CONSERVATION COMMISSION AGENDA

The Conservation Commission will hold this meeting as a virtual meeting on Thursday, April 1, 2021 at 7:00 pm. No in-person meeting will take place at City Hall.

28-30 RIVERDALE PROPOSED CONDITIONS

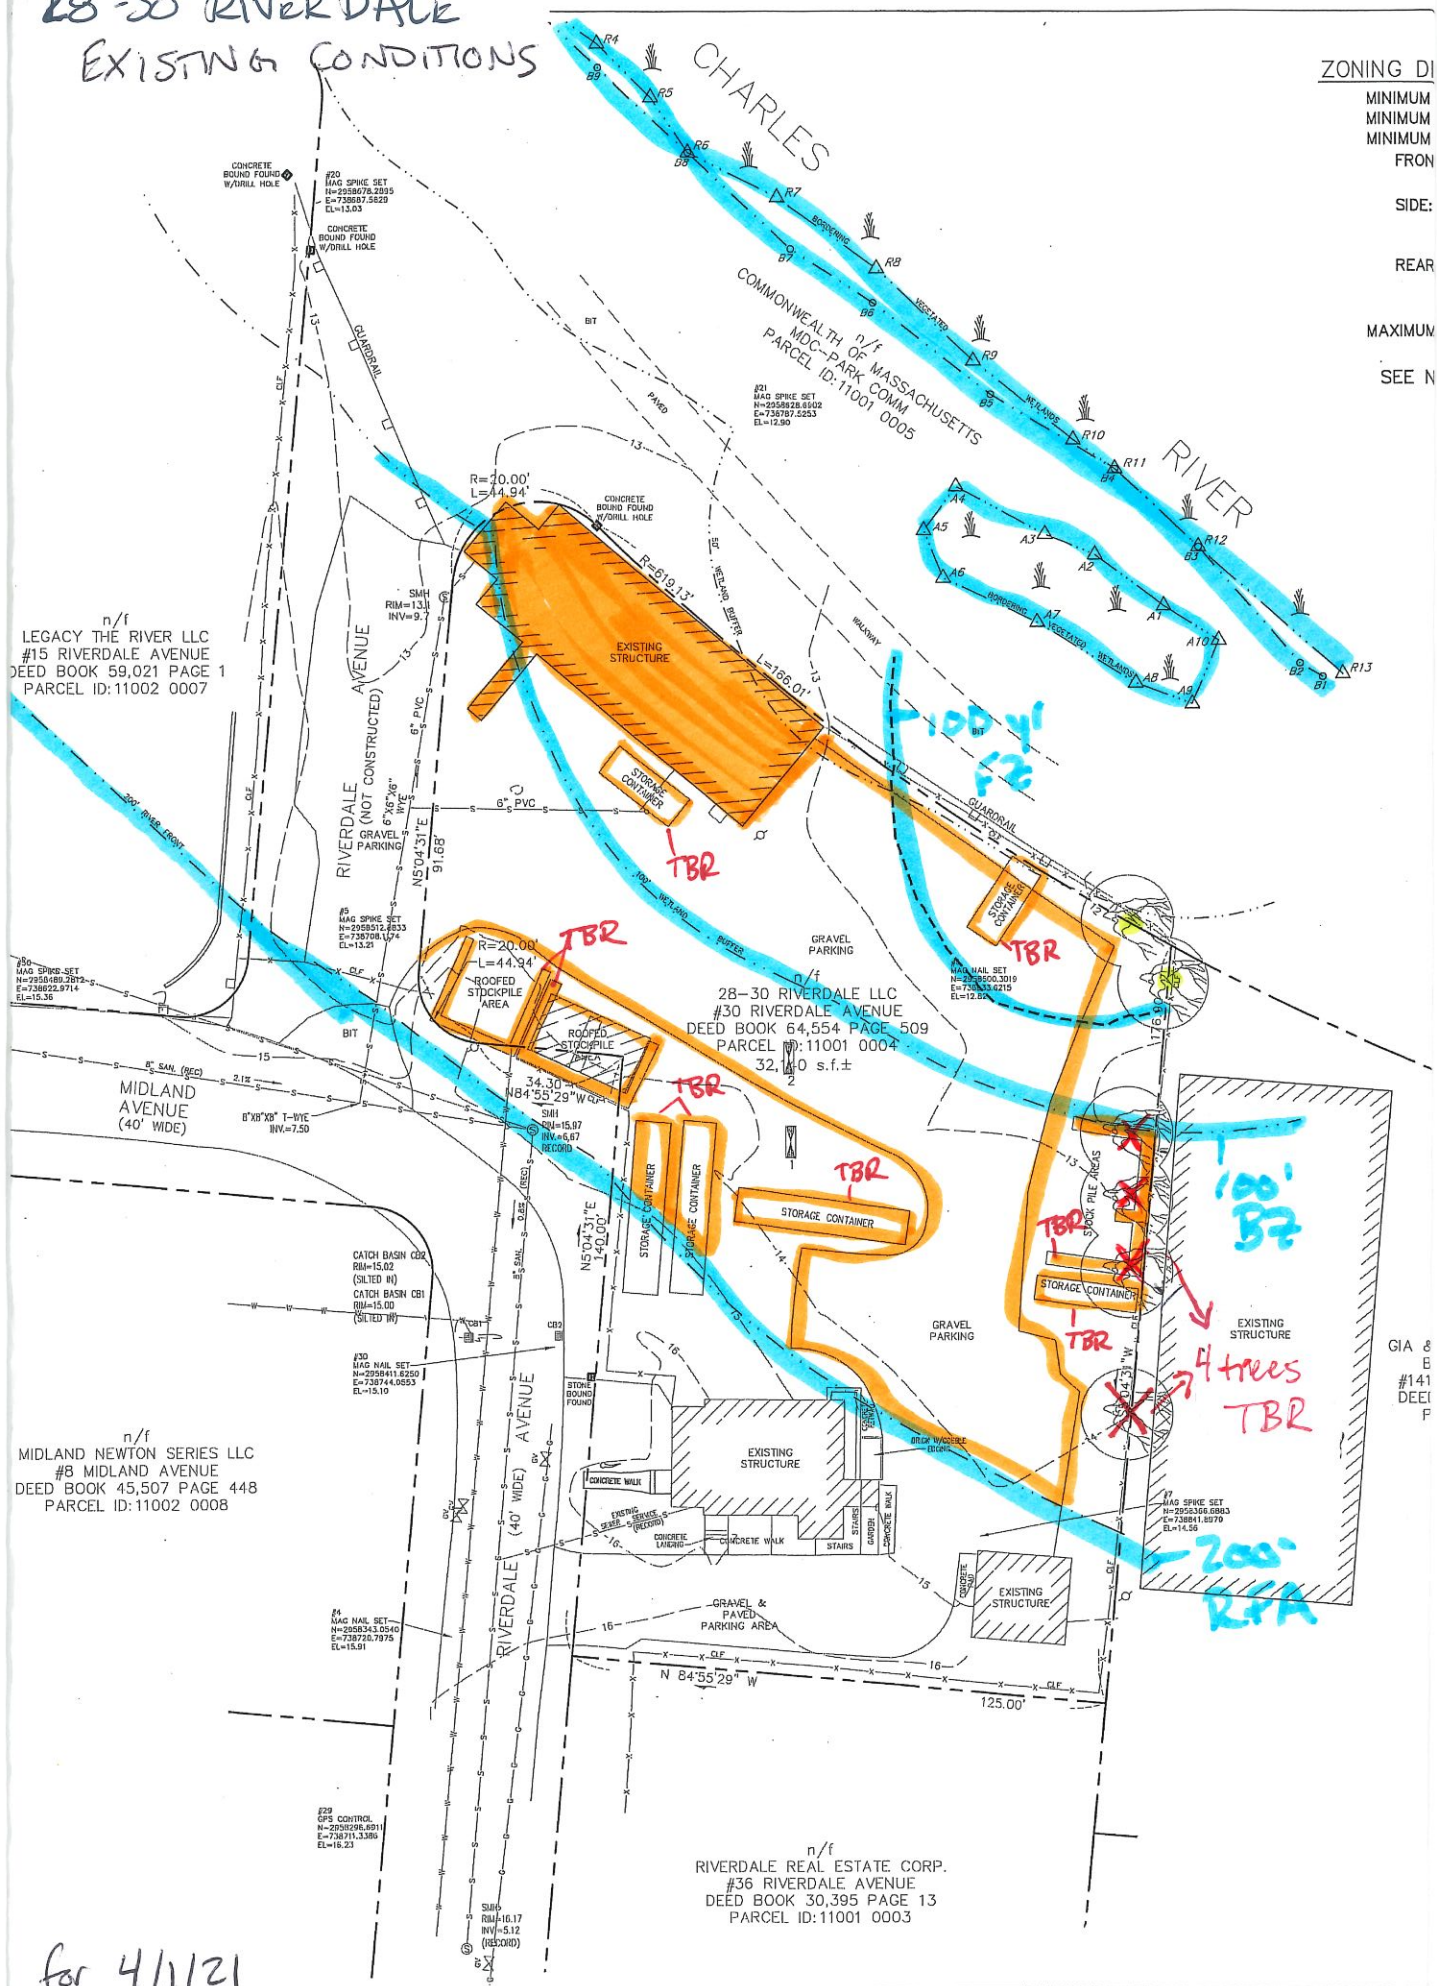
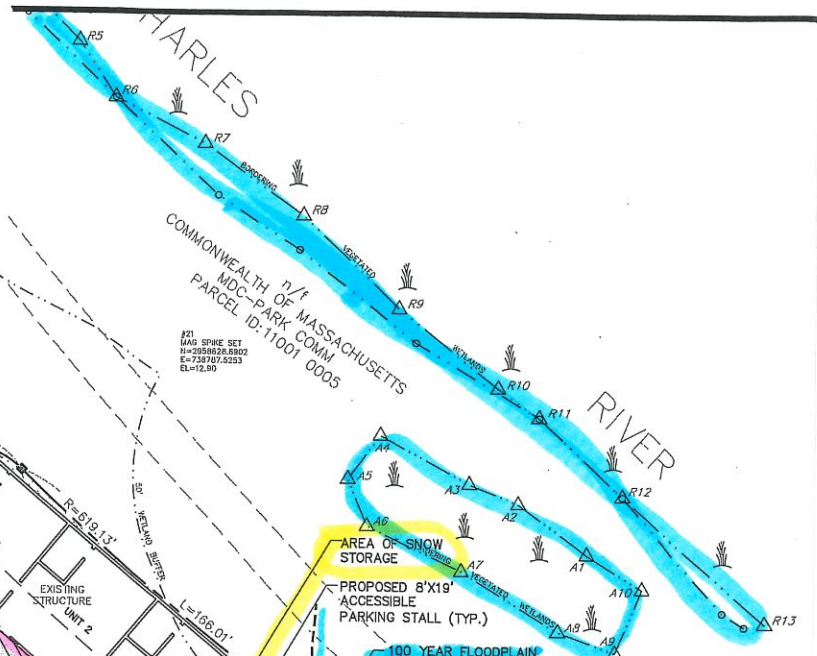
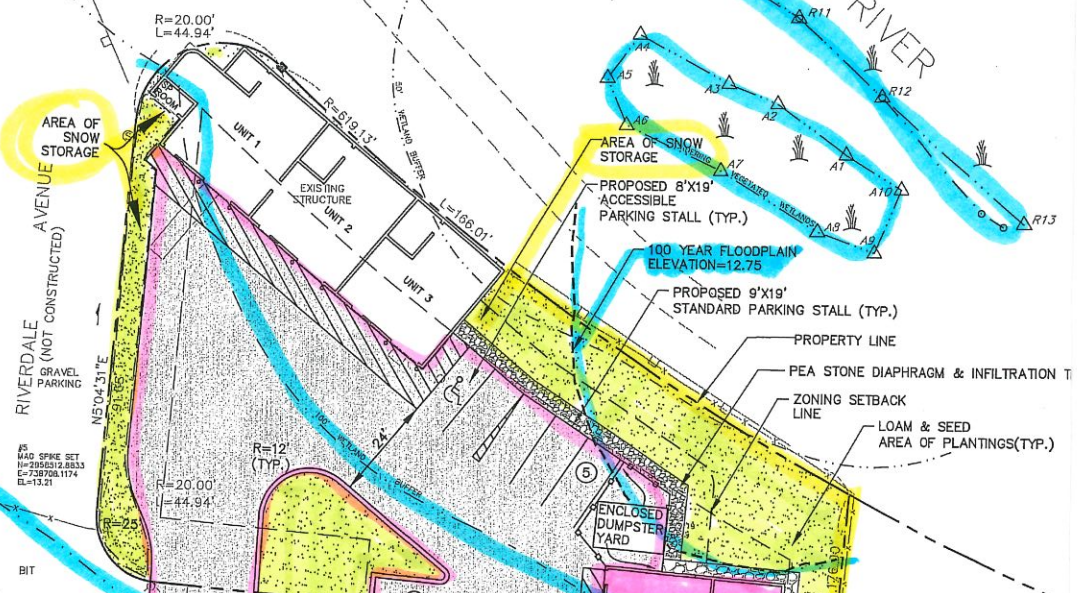
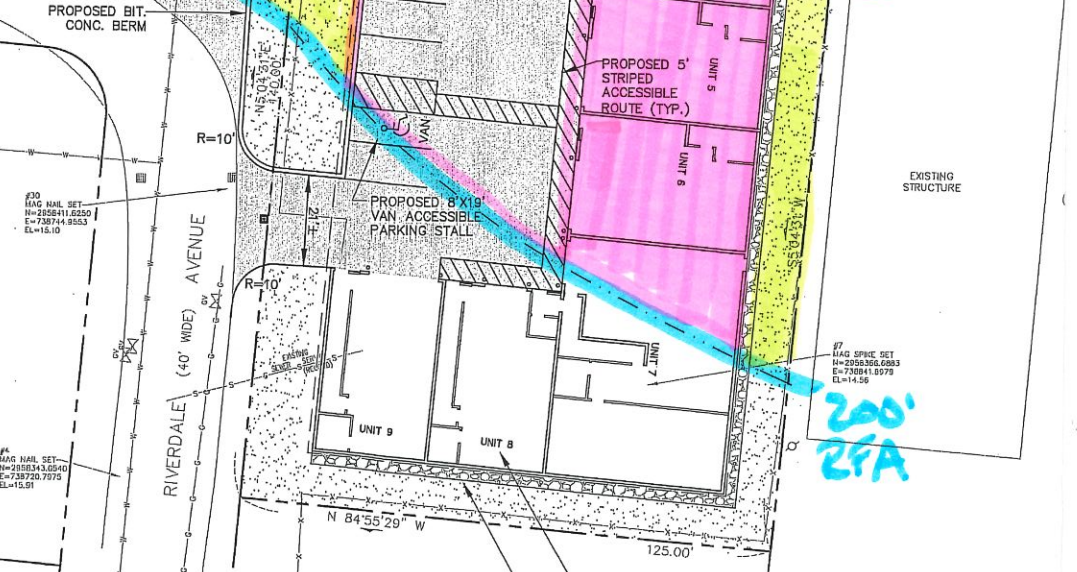
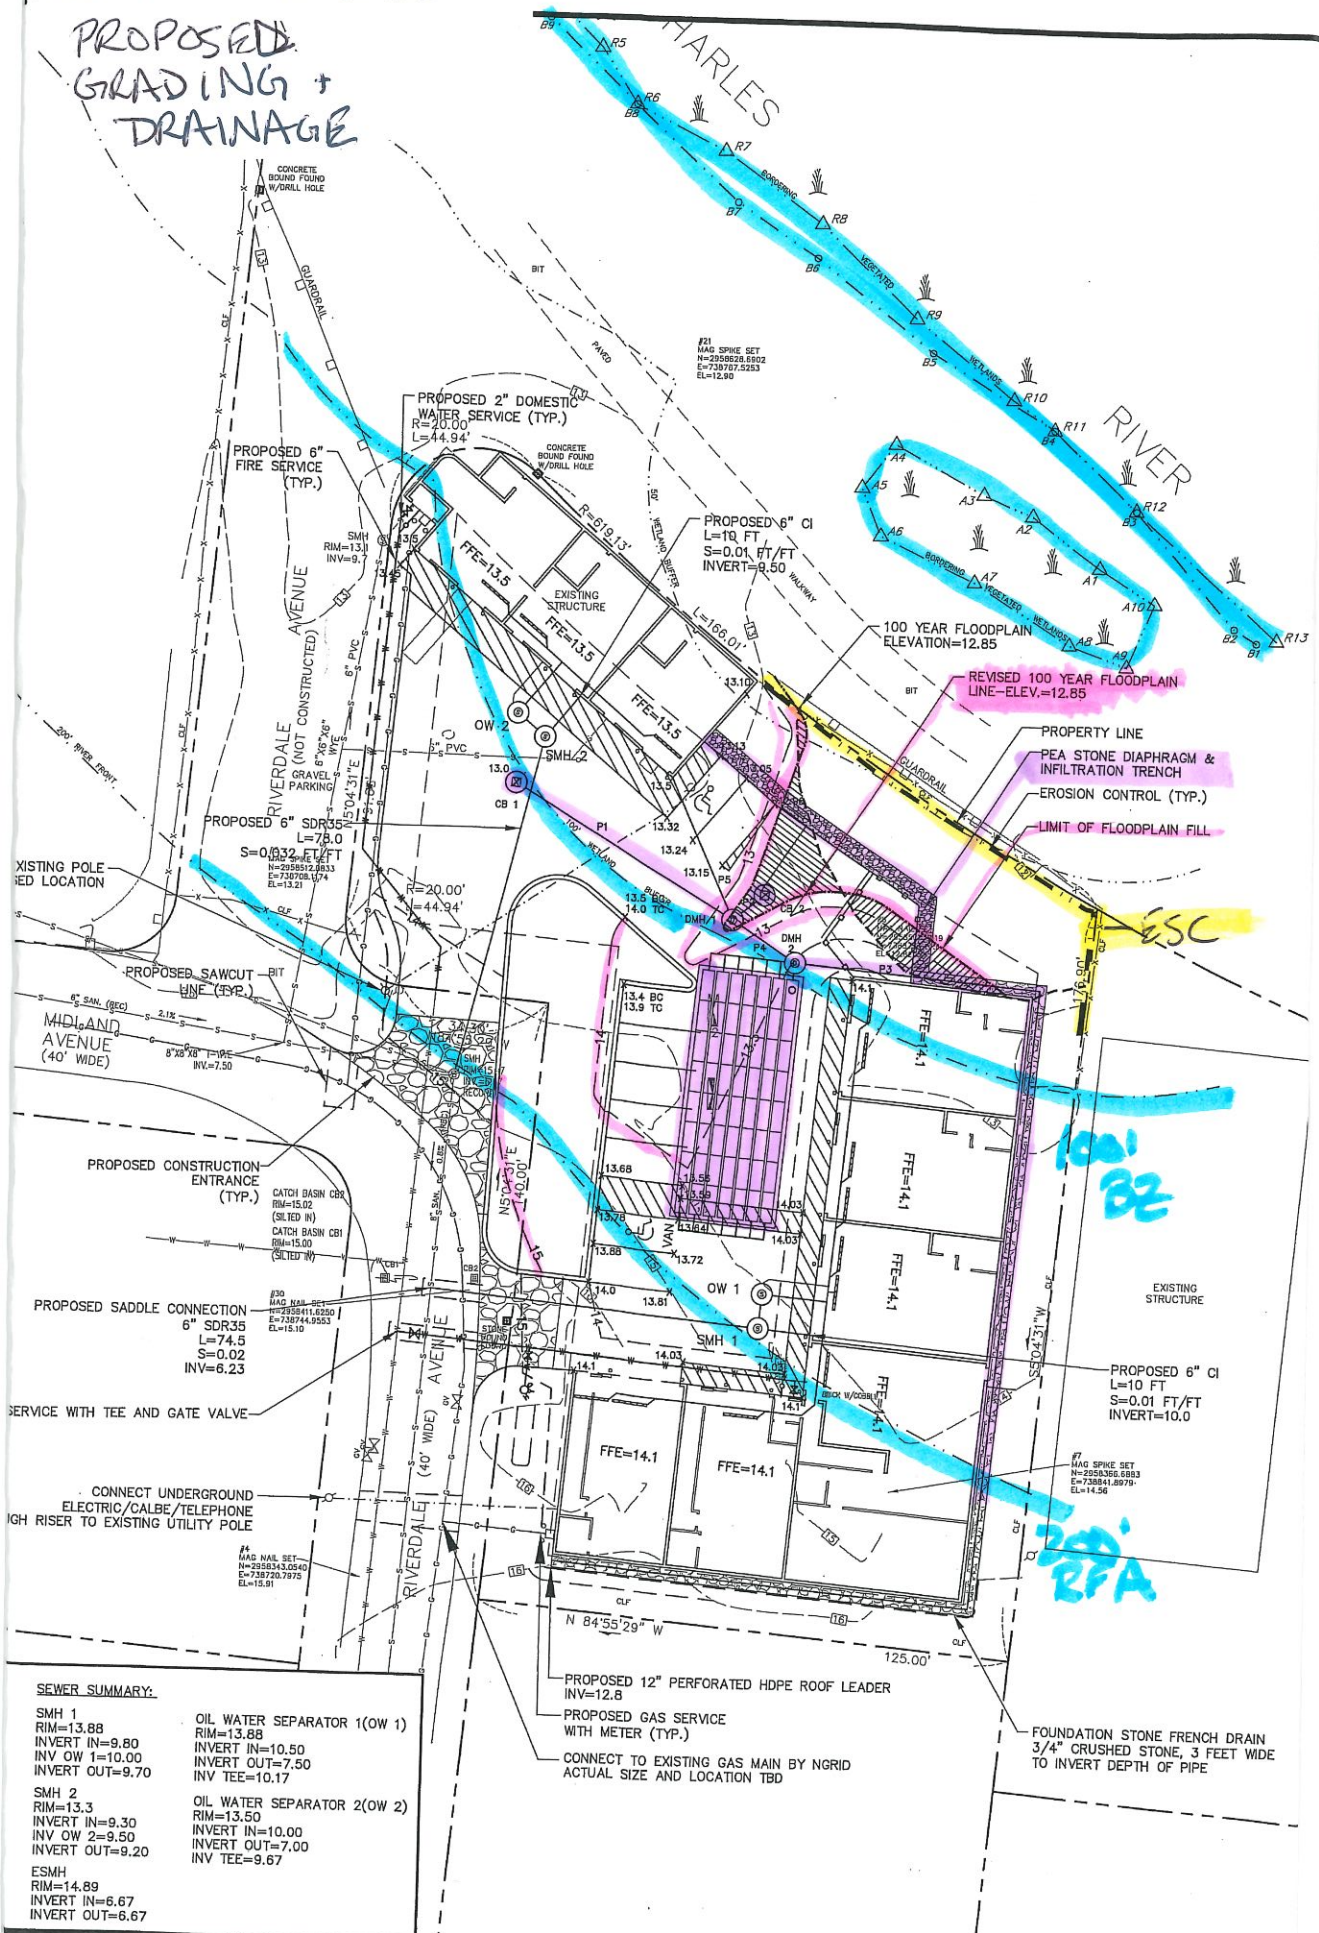
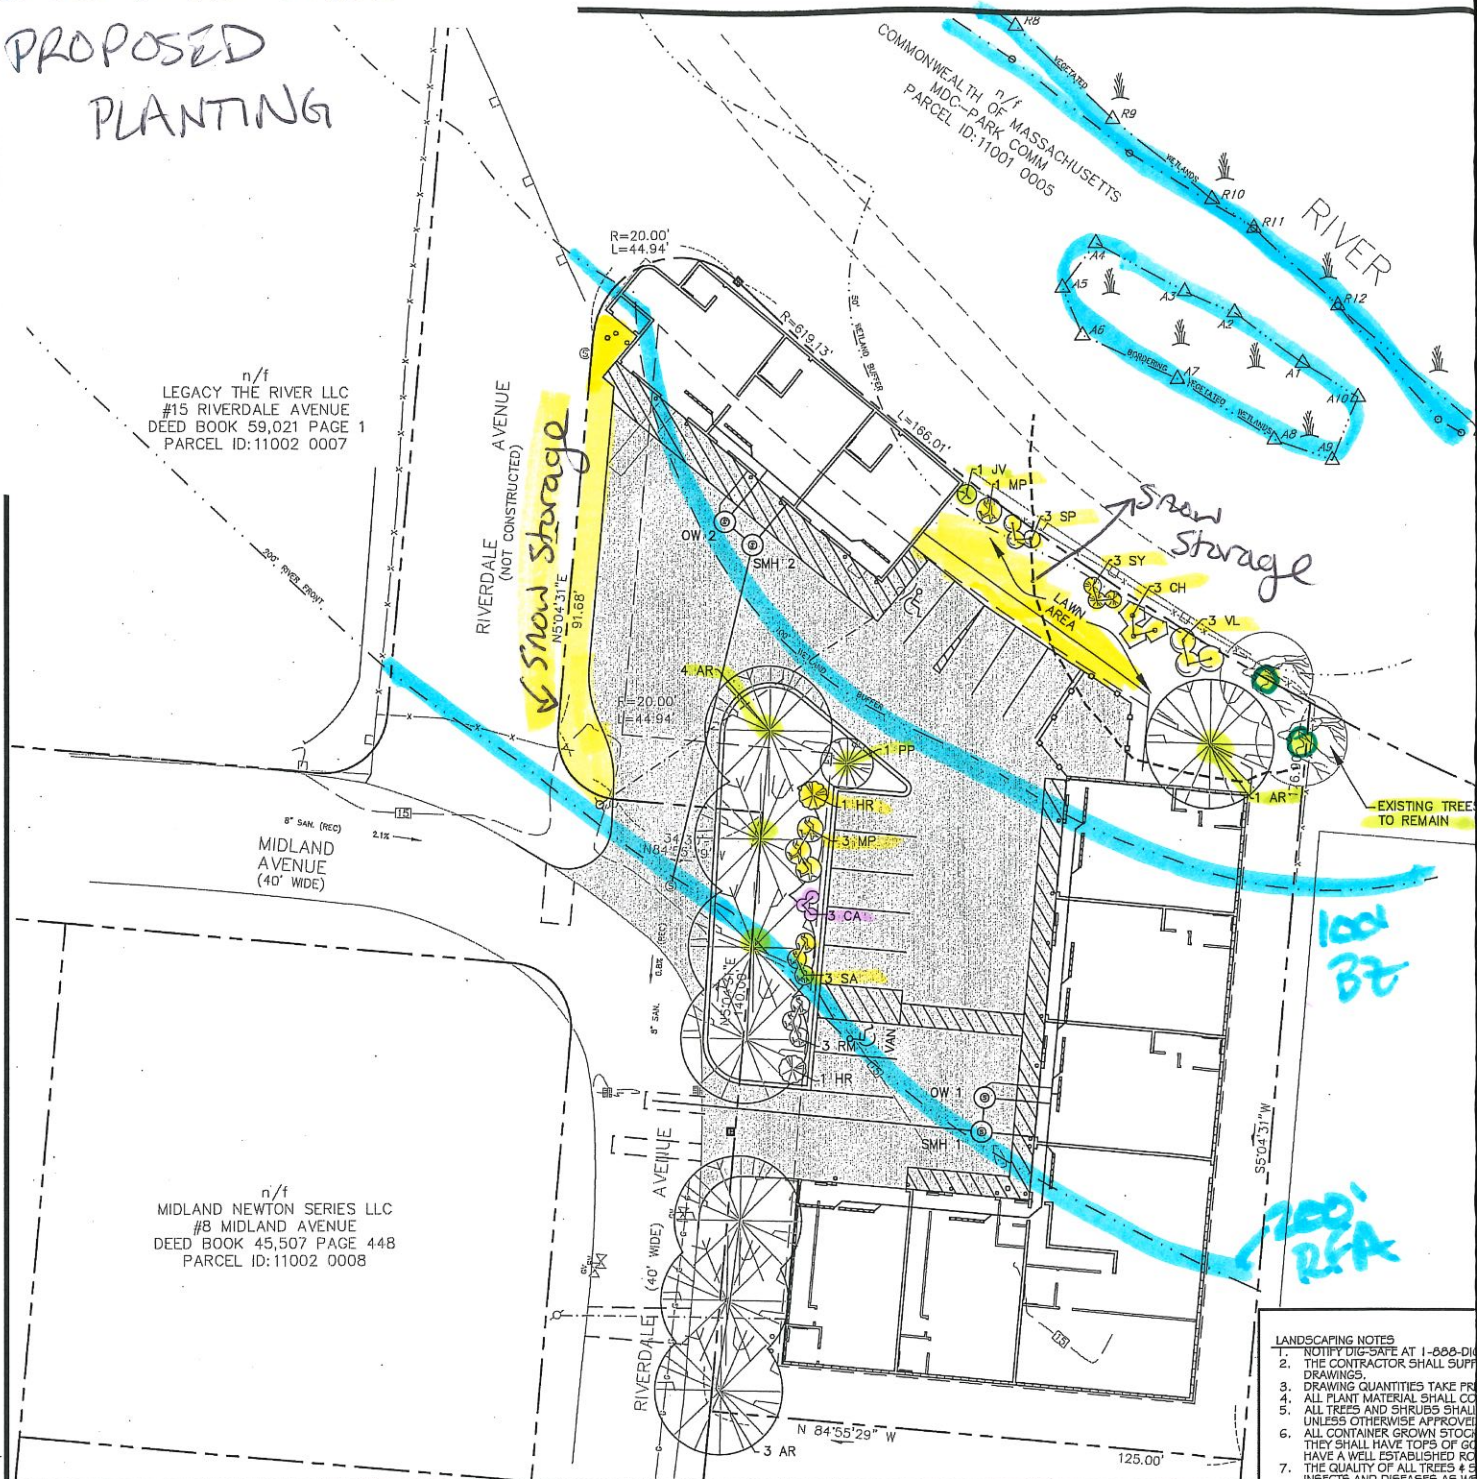
- On the revised plans it seems that erosion controls are only being proposed along the northeast corner of the property. Staff feel that a staked compost sock or entrenched silt fence (site is flat enough that both would be unnecessary) should be proposed along the full northern, eastern, and western property boundaries. Revised plans should be provided to show this.

- Staff are concerned that the proposed snow storage areas are not large enough to handle the snow that will come from the lot and so snow is likely to be pushed onto the plantings along the norther property boundary and outside the illustrated snow storage strip to the west.

- Applicant should provide a detail for tree protection and a revised layout and materials plan to show the protection of the two trees on the northern property boundary.

- Staff would like clarification of the depth to Estimated Seasonal High Groundwater (ESHGW) to clarify the separation between the bottom of the proposed infiltration chambers and ESHGW.

- Compensatory flood storage must be provided as per the approved plans and must be documented in the as-built plans.
 - Approved, native mitigation plantings must be installed as per the approved plans and must survive 100% after 2 growing seasons.

- Signs indicating that snow may not be stored in the planting beds must be installed in field.

- Infiltration system must be installed per the plans and must be signed off on by the Engineering Department.
- The stormwater O&M plan must be adhered to in perpetuity.
